Brightview Bethesda: Sketch Plan 320160010 and Preliminary Plan 120160010

Staff Report Date: 11/25/2015

- Two lots for an assisted living facility consisting of up to 120 dwelling units and 3,125 square feet nonresidential uses in an eight-story building and retention of an existing office building;
- Located in the northeast quadrant of the intersection of Rugby Avenue and Glenbrook Road in the Bethesda CBD;
- 1.39 gross acres zoned CR 3.0 C 1.0, R 2.75, H 90 T and CRN 0.5 C 0.5, R 0.25 H 35
- Woodmont Triangle Amendment to the Bethesda CBD Sector Plan* area;
- Application accepted July 23, 2015;
- Applicant: Shelter Development, LLC.
- Review Basis: Chapter 50 and Chapter 59

- Staff recommendation: Approval of the sketch plan and preliminary plan amendment.**
- The project is being developed with the use of FAR Averaging (density transfer) from two sending properties. The density transfer will send 19,000 square feet of residential floor area from the sending sites to the subject property.

SKETCH PLAN

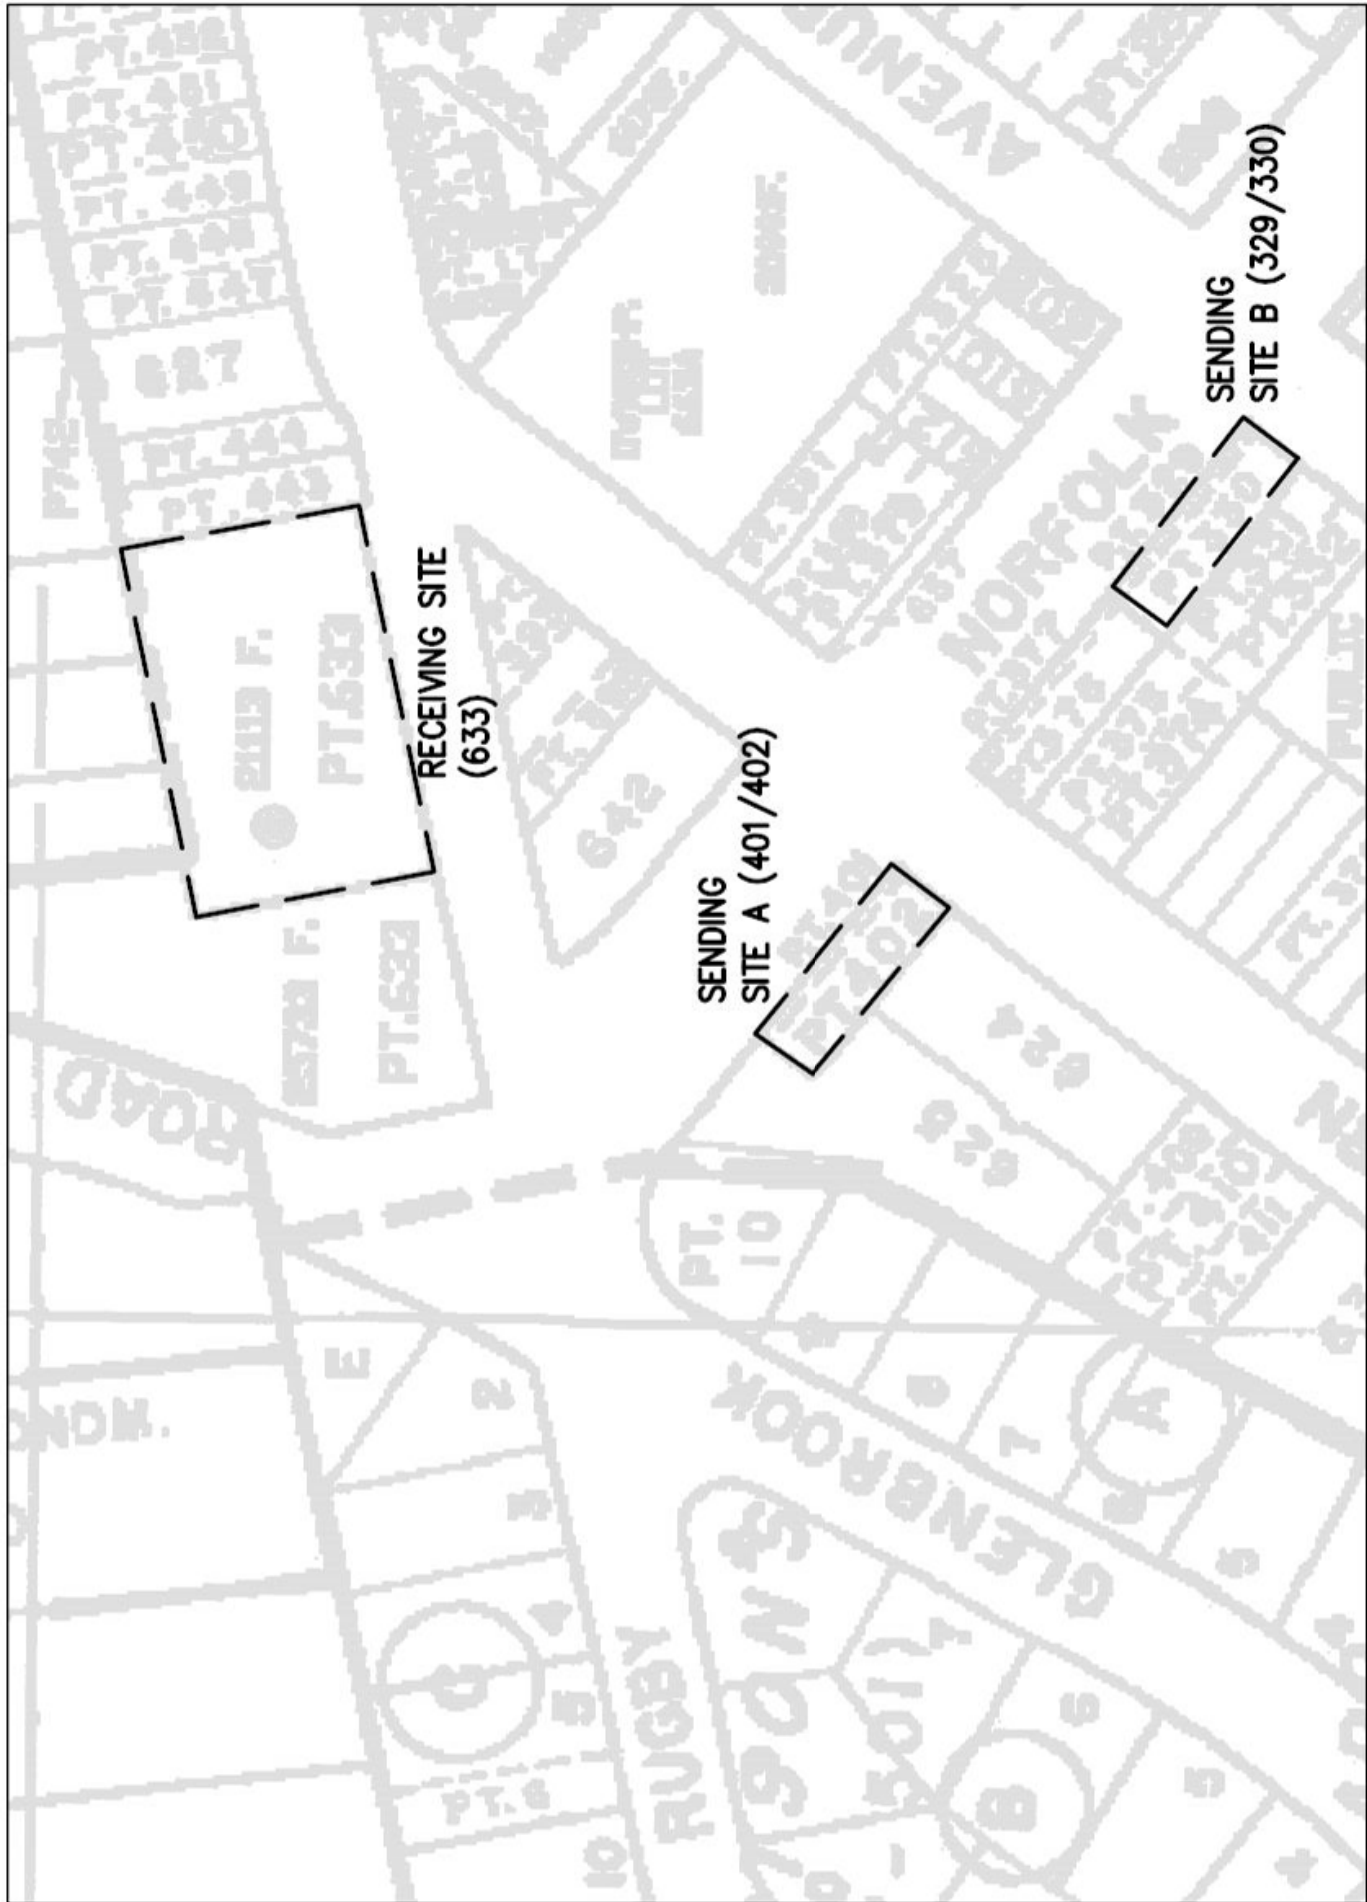
We have completed our review of the revised amended preliminary plan dated September 29, 2015. An earlier version of this plan was reviewed by the Development Review Committee at its meeting on August 17, 2015. We appreciate the applicant's consultant's September 29, 2015 letter of responses to the DRC review comments. We recommend approval of the revised plan, which provides a single underground entrance for the site, subject to the following comments:

1. Right-of-Way dedication: This section of Rugby Avenue is shown as a fifty (50) foot wide right-of-way – which is consistent with the [minimum] right-of-way recommended in the 1994 Approved and Adopted Bethesda CBD Sector Plan and the pending Bethesda Downtown Plan. This roadway is also classified as a business district street.

The scaled pavement width on the plan appears to be approximately thirty (30) feet – which is acceptable pavement for an urban business district street with two travel lanes and parking on one side of the road following passage of Expedited Bill 33-13. (Although metered parking spaces exist on portions of both sides of Rugby Avenue in the vicinity of this site, we are not advocating widening the pavement.)

2. The proposed "15" RCP" on-site storm drain as should be labelled on the plan as "Private."
3. This project is located in the Bethesda CBD Policy Area (Transit – Exempt, Roadways – Adequate). Therefore, there is no Transportation Area Policy Review ("TPAR") payment required for this site.

4. Prior to approval of the record plat, the applicant's consultant will need to submit a revised Sight Distances Certification (showing the single driveway only) for Executive Branch approval.

6. Based on the proposed site development and gross floor area, we concur with the applicant's proposal to provide a single off-street SU-30 truck loading to service this site. We have accepted the consultant's truck turning diagrams.
